# LIGO Bill of Materials

**Source Data From:** WhiteningInterfaceSplit\_v3.PrjPCB  
**Board Designed By:** R. Abbott  
**Board D-number:** D1300520  
**Board Revision:** v3  
**Variant:** None

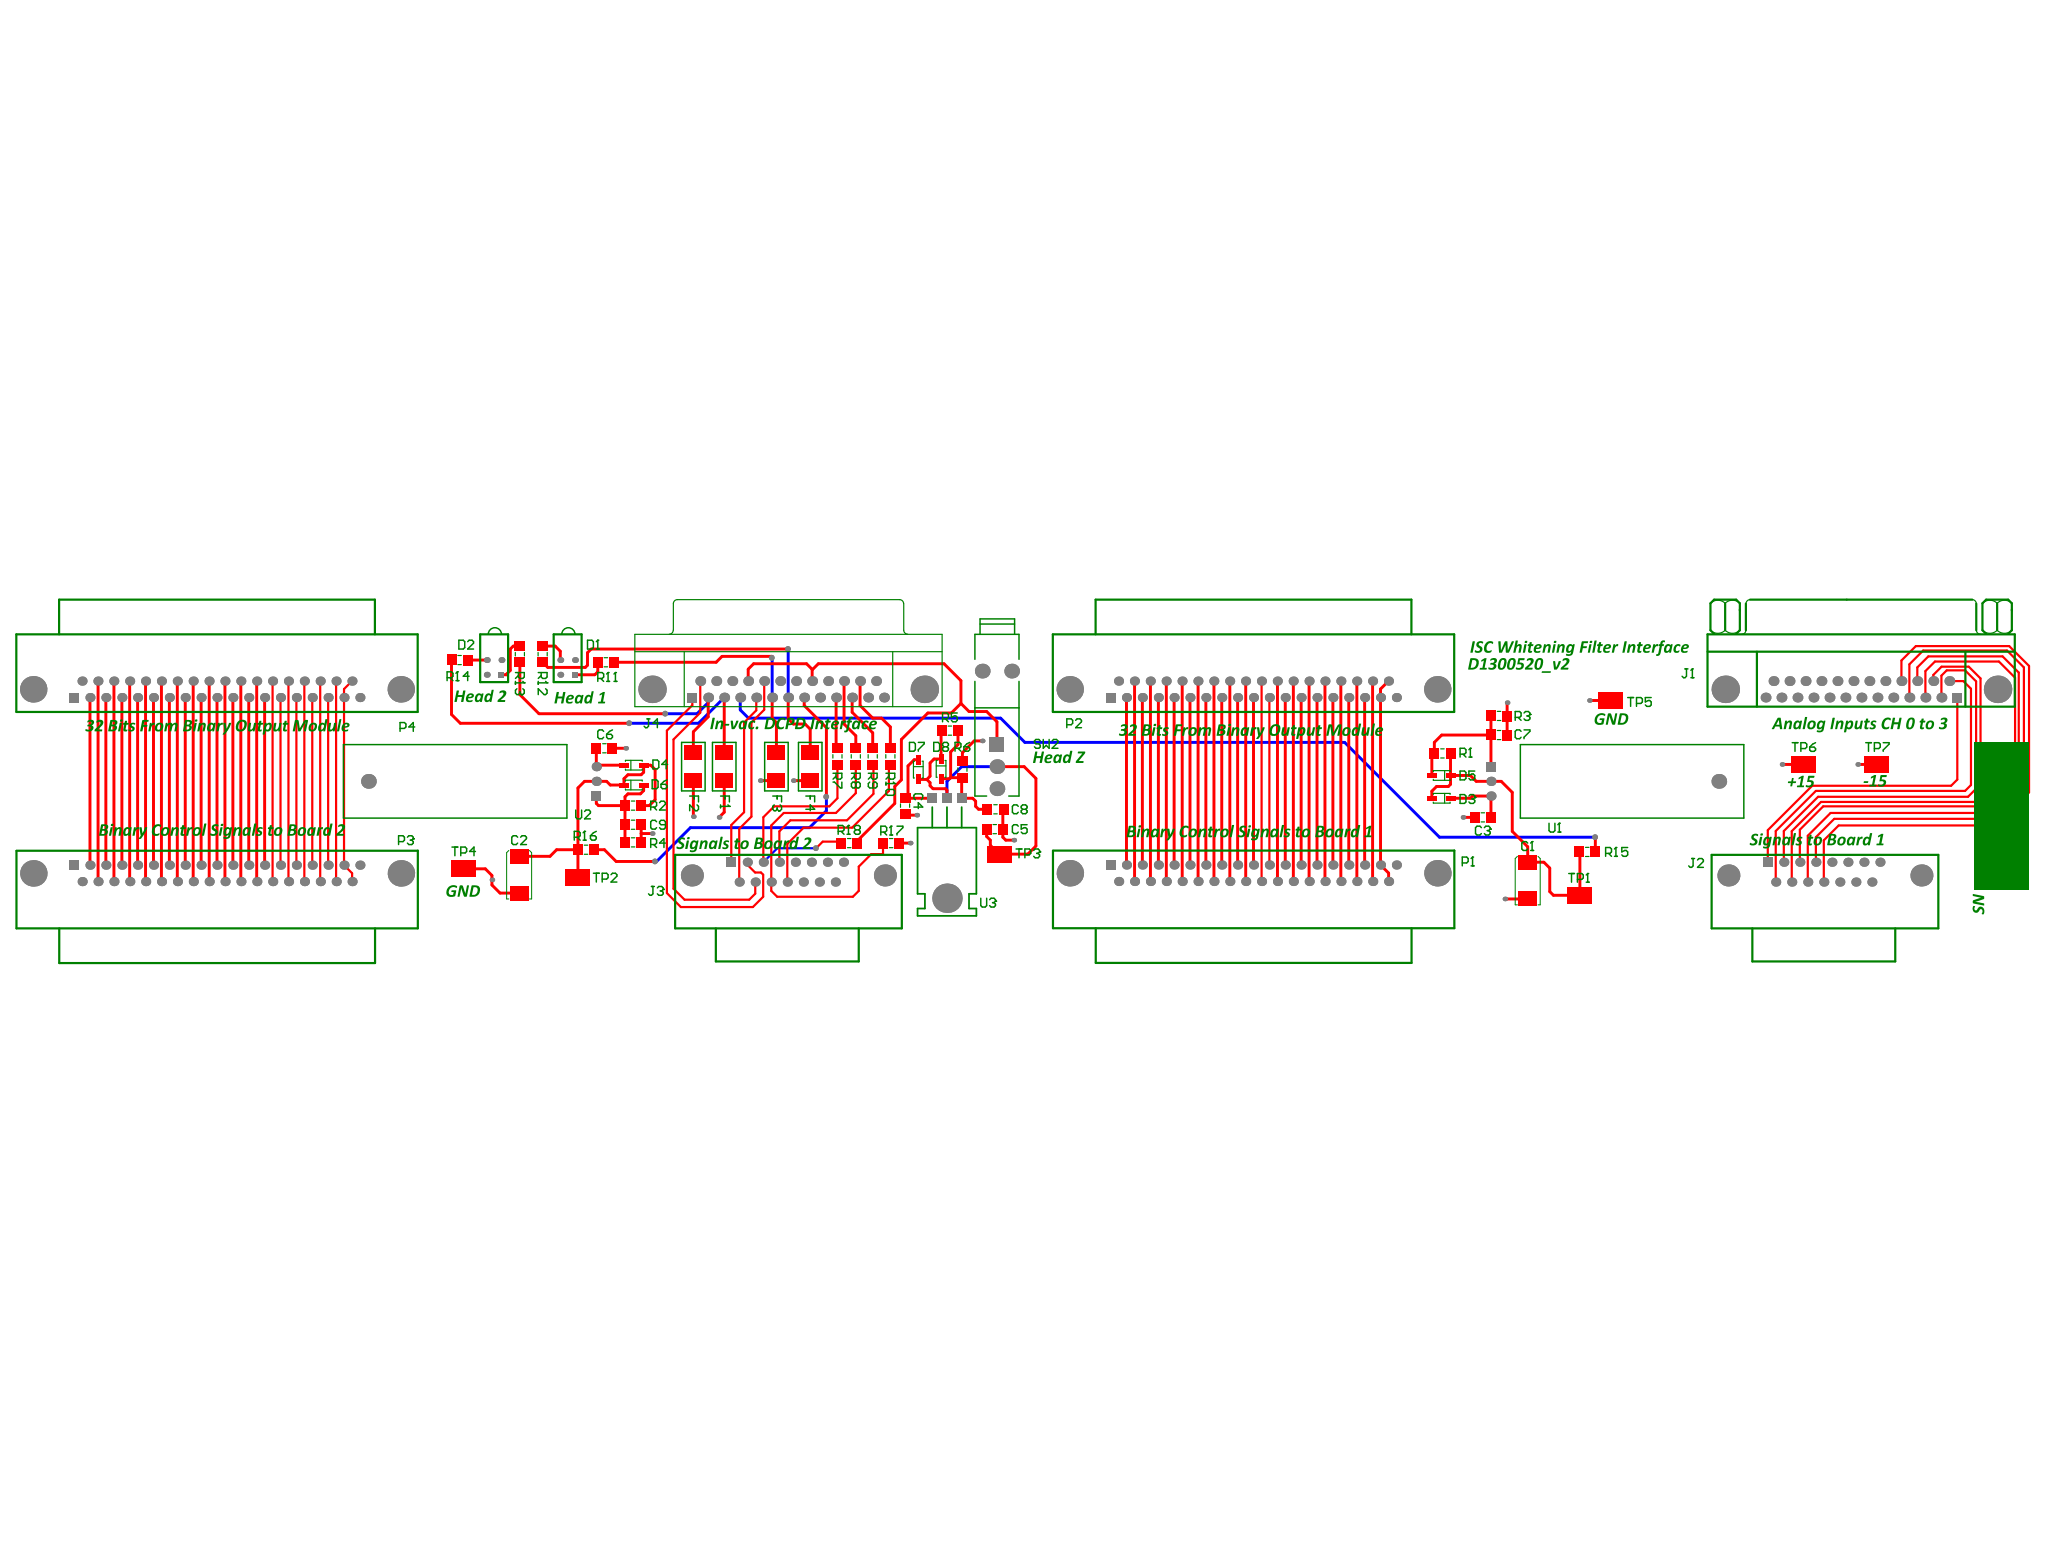
Version History:  
 Version 1. Initial Release  
 Version 2 - S2, the Head Transimpedance Switch was mounted backwards on the PCB. Pinout of 25 pin connector serving the DCPD was wrong on V1. Blown fuse LEDs were labeled backwards. V2 fixes these errors.  
 Version 3 - ECR E1600192  
 1. Remove R7, R8, R9, R10, R17, R18  
 2. On the back side of the circuit board, use hot glue to affix a 220pF leaded plastic film capacitor (399-7684-ND) each between 14 pins 1, 14, 5, 18 to 13 pins 3, 11, 4, 12 respectively using jumper wire as needed.  
 3. Version 2 PCB is still current
